Montgomery Planning

01/26/2023

Rustic Roads Functional Master Plan Update

Work Session #2

Google Street View of Mount Carmel Cemetery Road

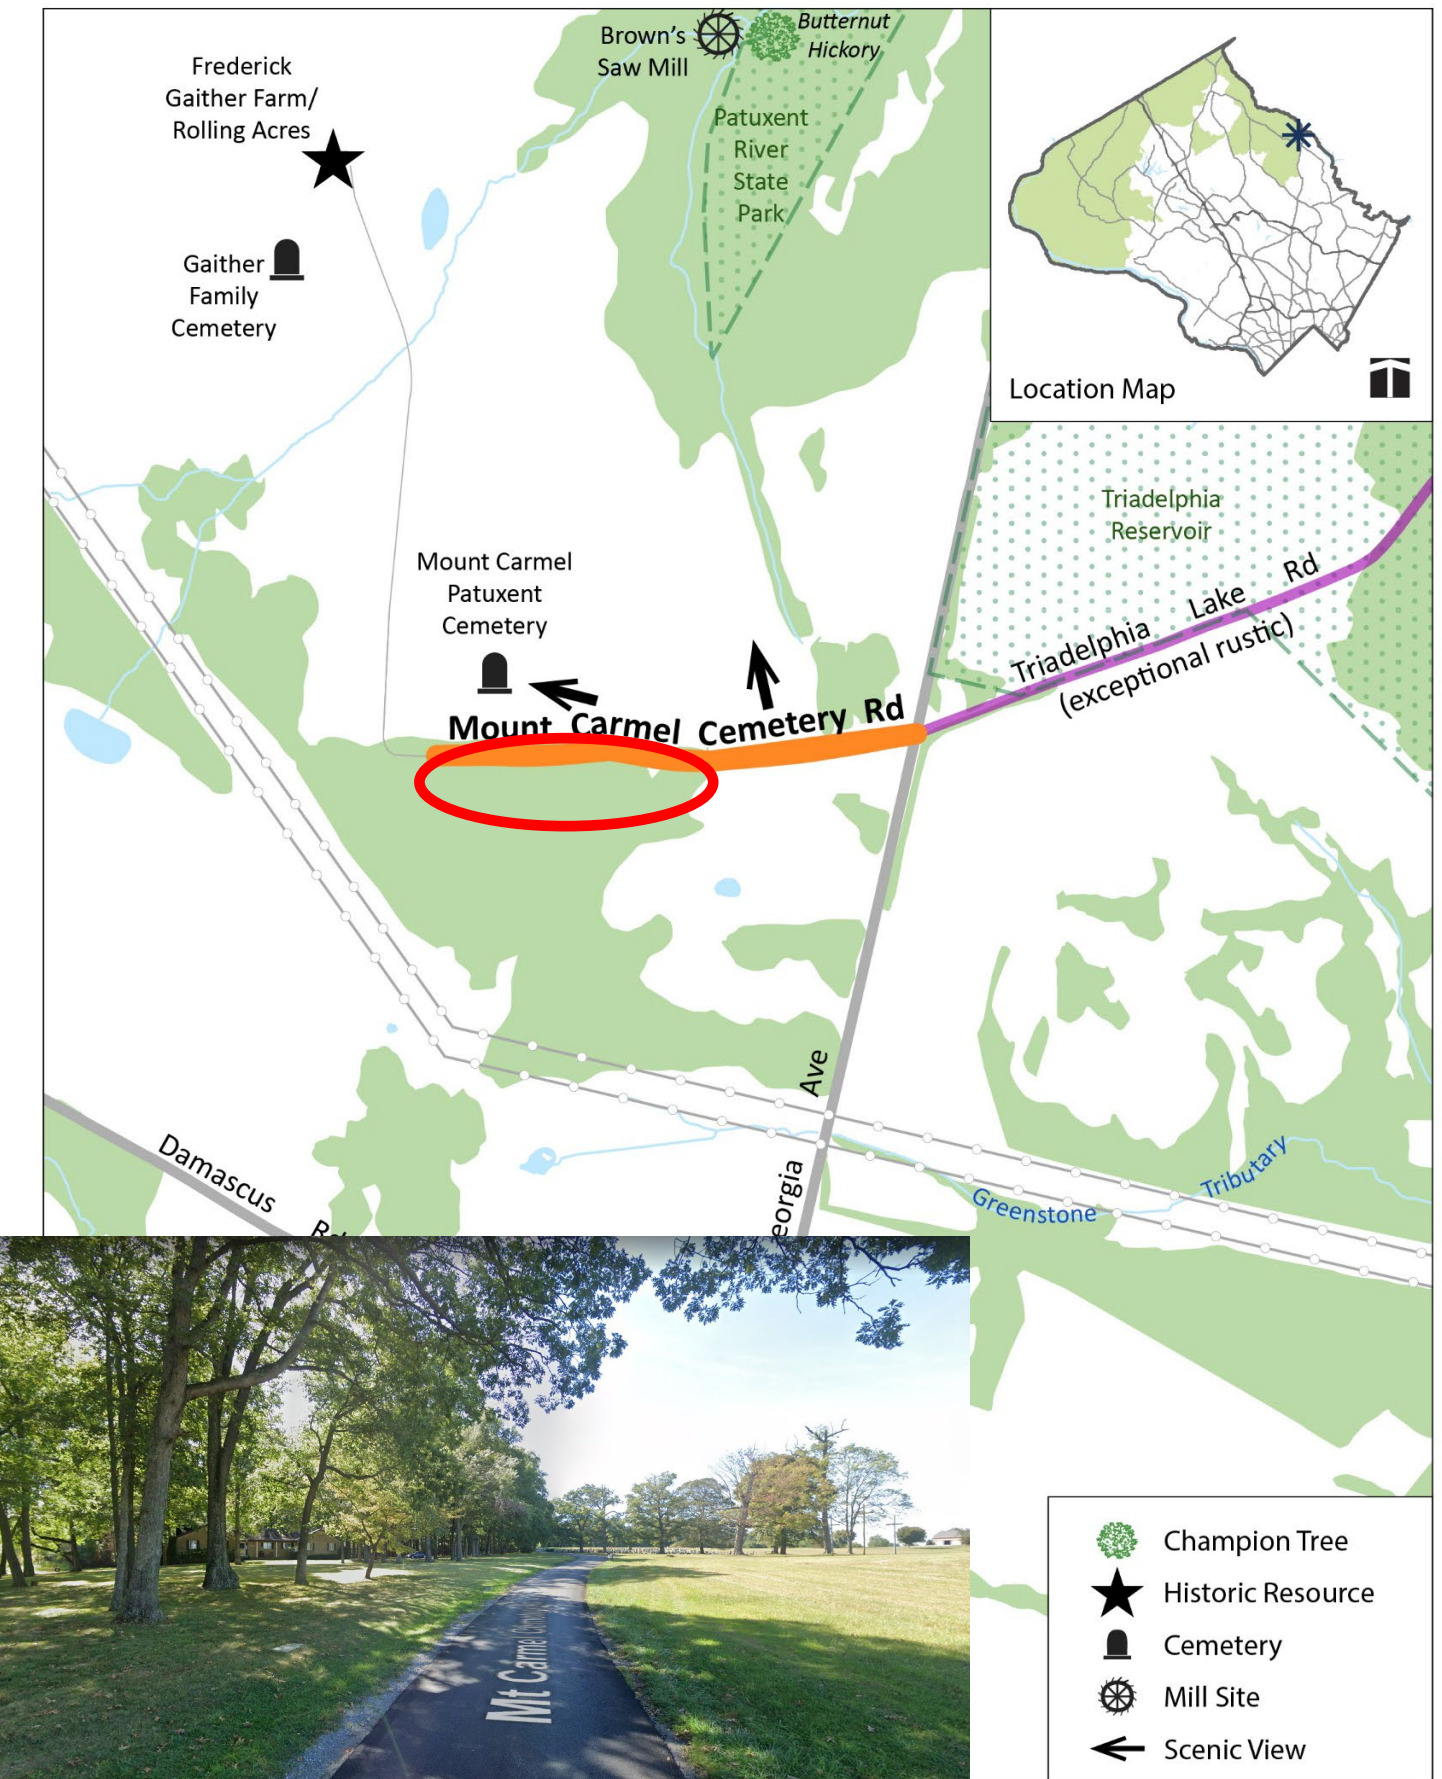
- Add mature trees on the south side of Mount Carmel Cemetery Road as a significant feature. (RRAC)

- Do not add significant feature.

- The area is already shown on the map as a forested area, but it does not rise to the level of a significant feature.

Bing Streetside View of Mouth of Monocacy Road

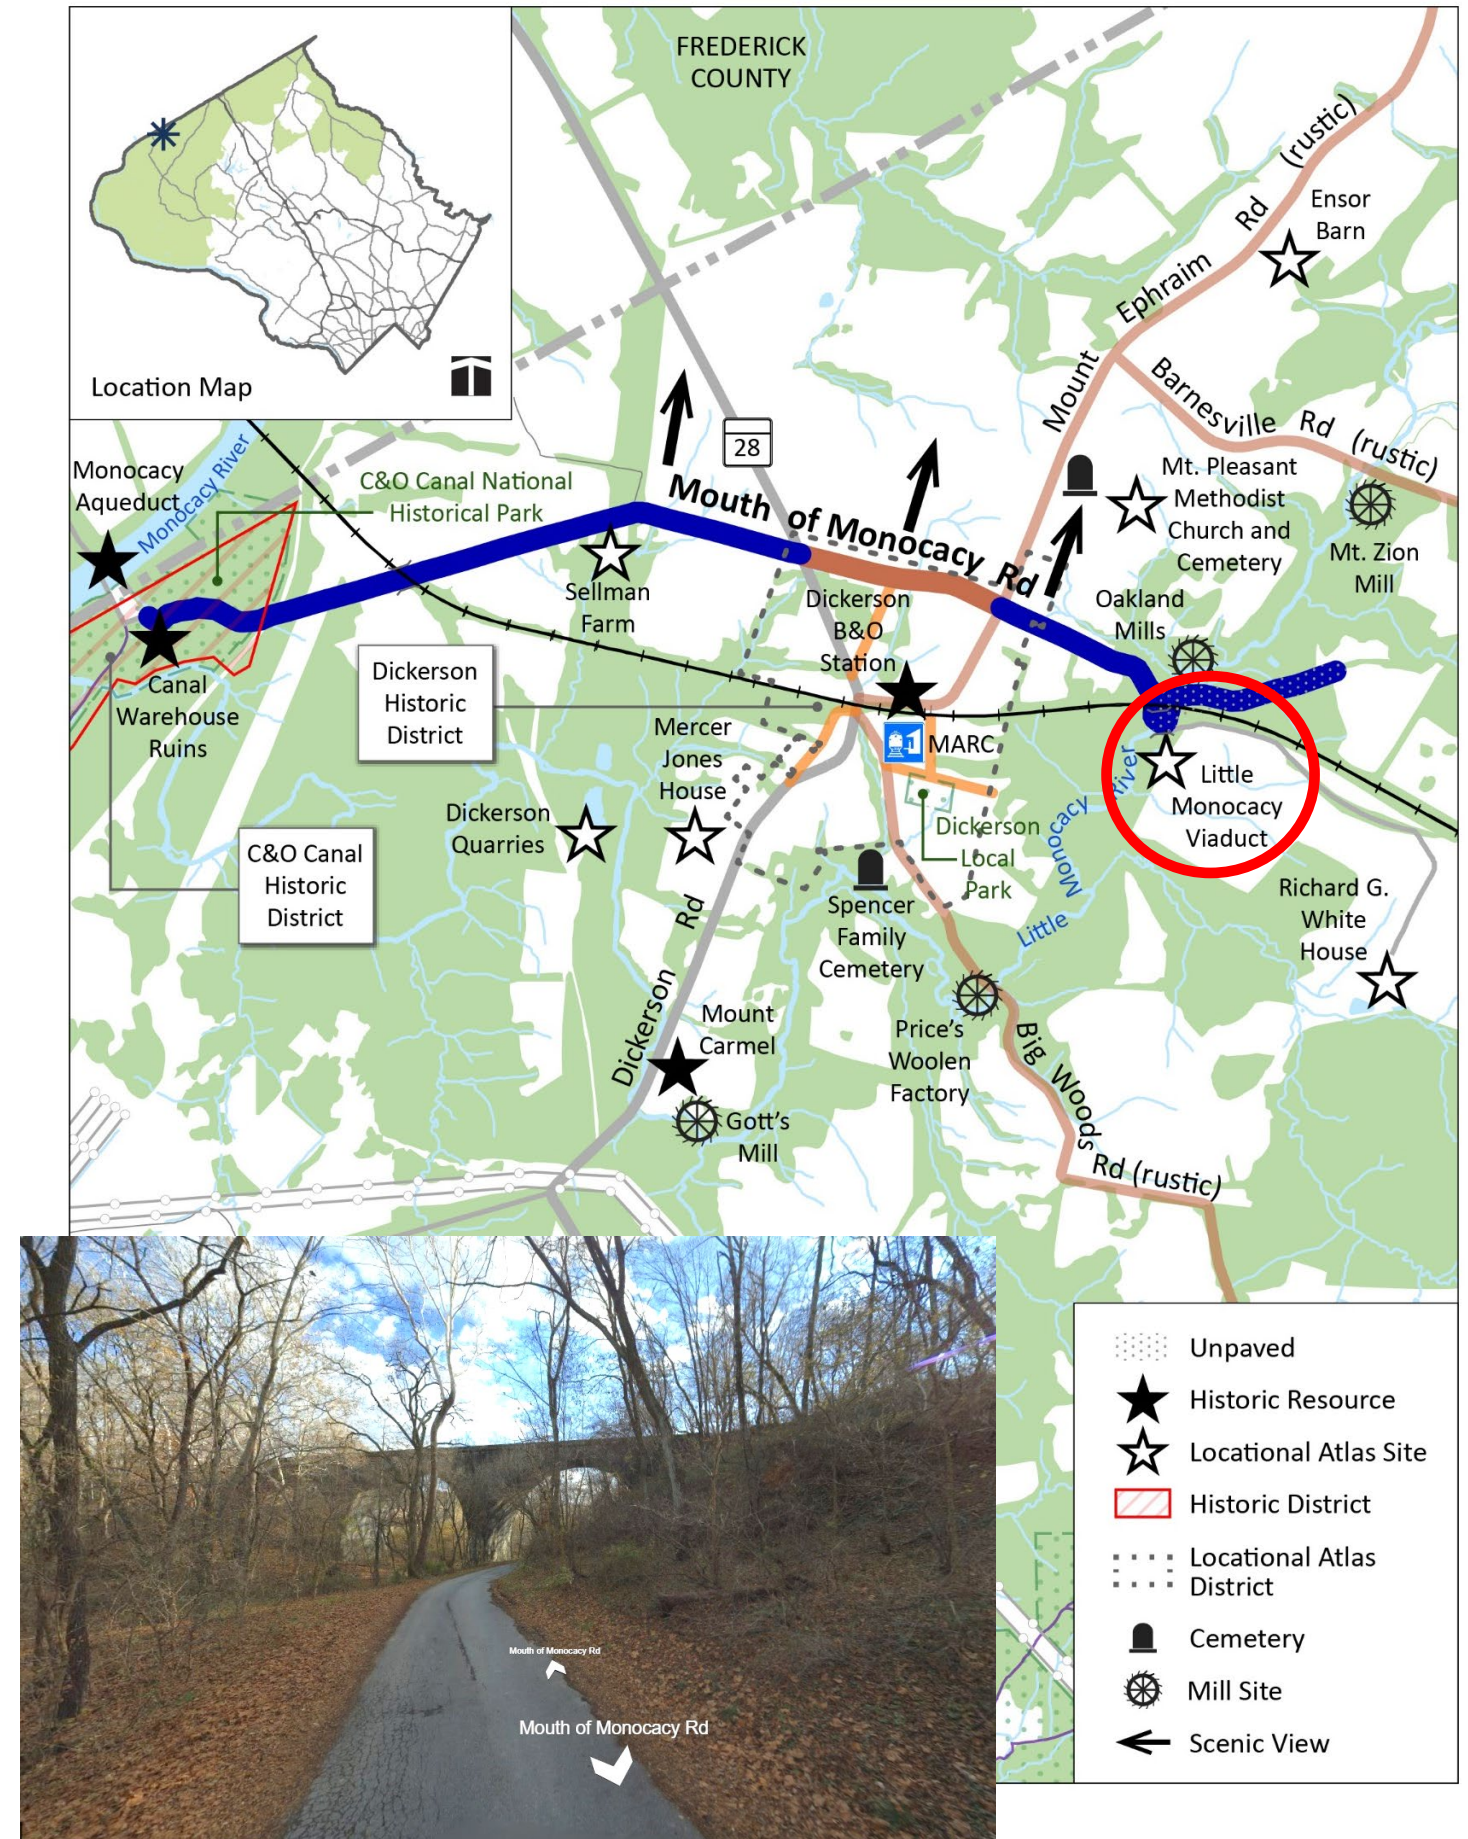
- Include the Little Monocacy Viaduct as a significant feature. (RRAC)

- Keep the text as is.

- The road profile already specifies “Alignment approaching and under the Little Monocacy Viaduct” as a significant feature of the road. Due to the wide span of the viaduct, it is not close to the roadway and therefore is not an element of the road that MCDOT would be able to preserve or not preserve to maintain the road.
